Docket No. 52-001

SUBJECT: REMAINING ACTIONS ON THE ADVANCED BOILING WATER REACTOR (ABWR)  
REVIEW

STAFF FEEDBACK ON ADVANCED BOILING WATER REACTOR (ABWR)  
STANDARD SAFETY ANALYSIS REPORT (SSAR) AMENDMENT 34,  
TECHNICAL SPECIFICATIONS (TS), AND ASSOCIATED CERTIFIED DESIGN MATERIAL (CDM)

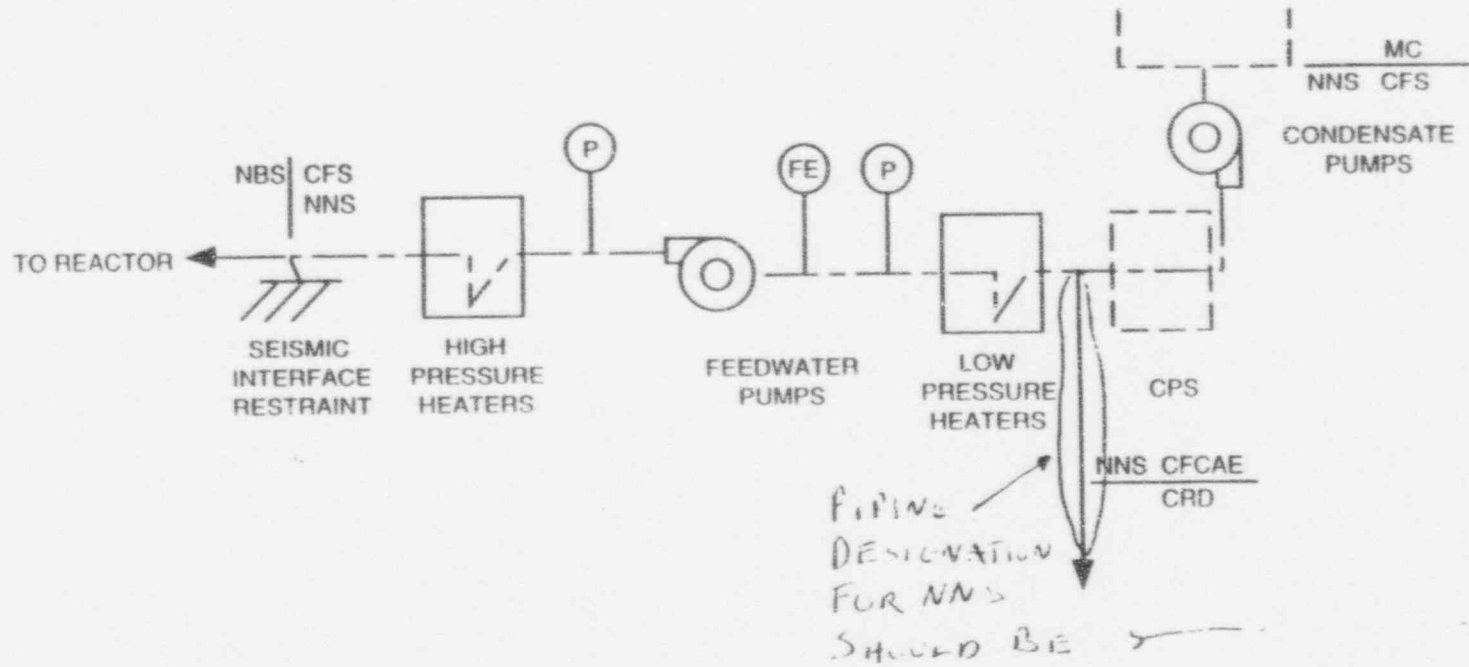
The Emergency Filtration System is considered OPERABLE when the individual components necessary to control operator exposure are OPERABLE in both divisions. A division is considered OPERABLE when its associated:

- a. Fan is OPERABLE;
- b. HEPA filter and charcoal adsorber are not excessively restricting flow and are capable of performing their filtration functions; and
- c. Heater, ductwork, valves, and dampers are OPERABLE, and air circulation can be maintained.

In addition, the MCAE boundary must be maintained, including the integrity of the walls, floors, ceilings, ductwork, and double entry doors with vestibule between.

*at a positive pressure of at least .32 mm of water gauge relative to atmosphere.*
